From: Simon Davis
Sent: 22 June 2021 11:16
To: Sparkes, Jessica [REDACTED]
Cc: Claire Potts <Claire.Potts@arun.gov.uk>
Subject: RE: *EXTERNAL: RE: Drove Lane, Yapton Y/49/21/RES

I thought it would be useful before this afternoon's meeting to set out all of our current issues with the scheme. Perhaps then we can go through these points at the Meeting. Please therefore see below the following summary of the points raised in the draft report that has been produced for Y/49/21/RES:

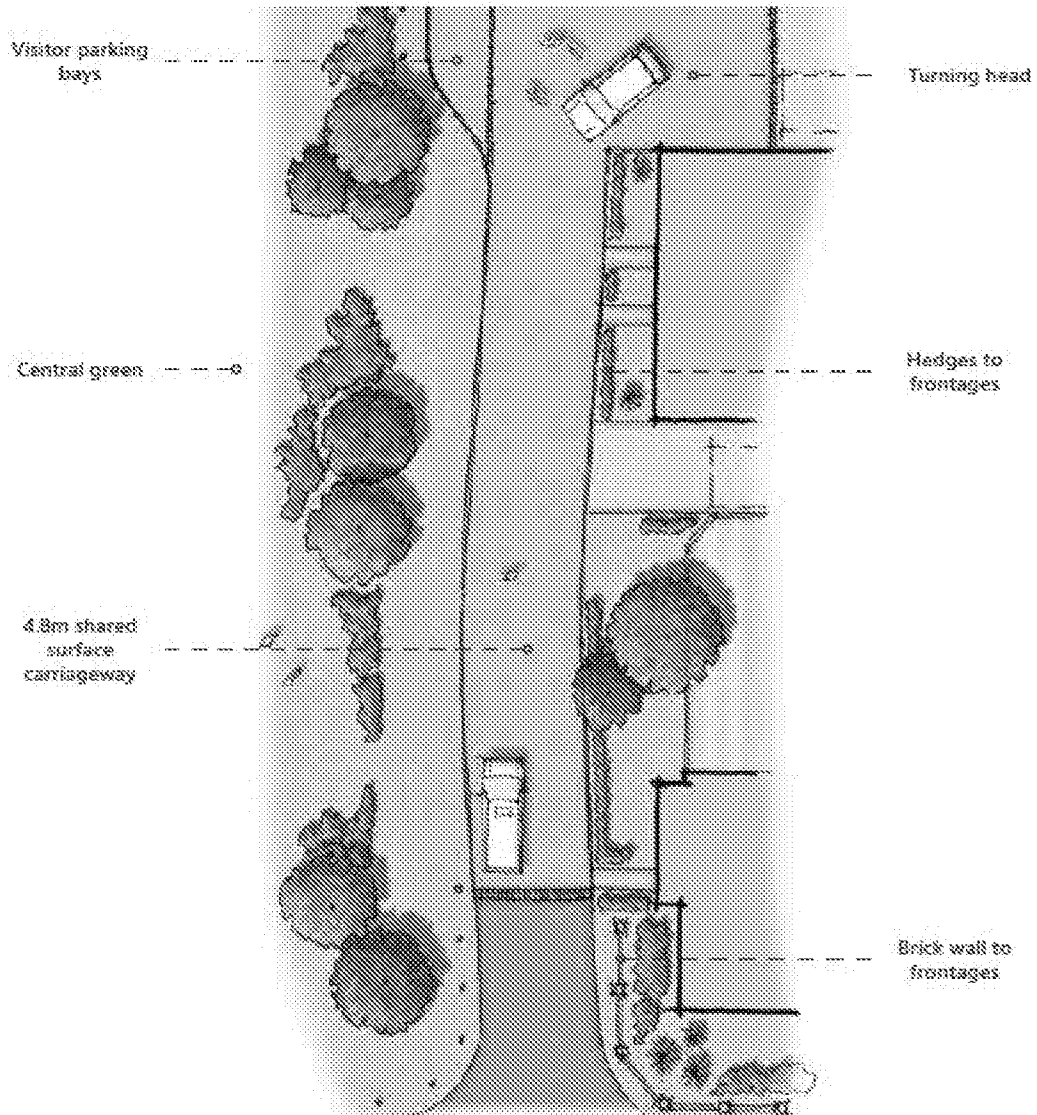
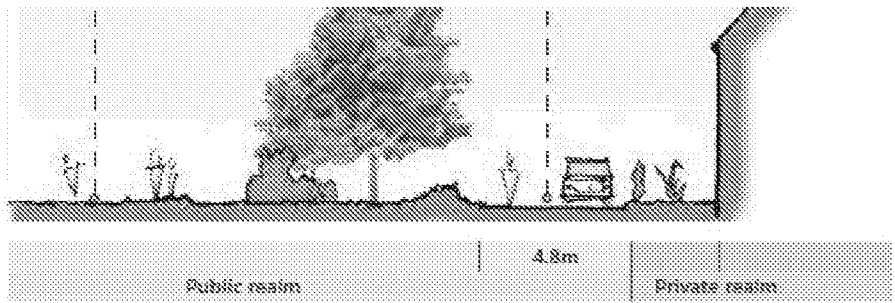
- Our longstanding preference is that the Central Green area of Public Open Space should be a larger area. This is a central feature of the site and will tie the two halves of the site together (i.e. the BDW and Hyde parcels). Above all, the treatment of the units overlooking the Open Space needs to be consistent between the two sites (i.e. units fronting the space with driveways/lanes in front). The approved Design Code illustrates how the 'drive' typology would work next to open space.

Figure 121: Example Plan of Green Spine

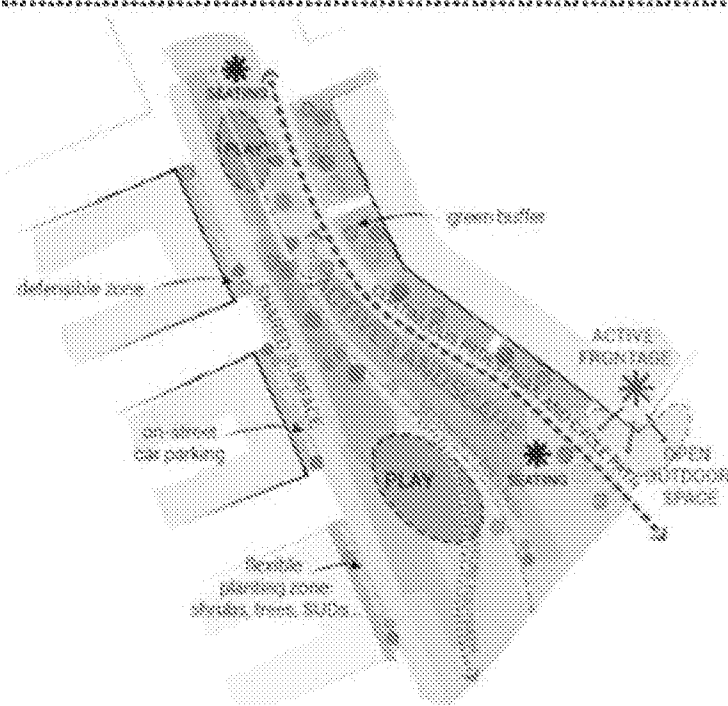
- The Green Link is mainly SuDS features which will decrease the amenity and usability of these spaces. The area in the image below is meant to be in two different character areas (Drove Park to the right of the Green Line and Drove Field to the left).

- There is no distinction in the layout between the two character areas, with flats and terraces in both areas. Whilst the density of each character area overall may fit with the Design Code, there needs to be more internal consistency within each character area in terms of layout.

- The frontage treatment varies along the Link with a mixture of driveways, properties fronting directly onto the Link. This leads to a lack of definition between public and private spaces and a lack of defensible private space for properties. The presence of SuDS features in the Green Link also means that the pathways/cycle path through the Link are directly adjacent to the SUDs basins, which has resulted in the need for hard boundary edging. The perimeter blocks need redesigning to resolve these issues.

- The Green Link is also diminished by the number of roads/driveways crossing it. The areas highlighted in yellow could be removed which would strengthen the Link. The red links

below should be

lanes/drives.
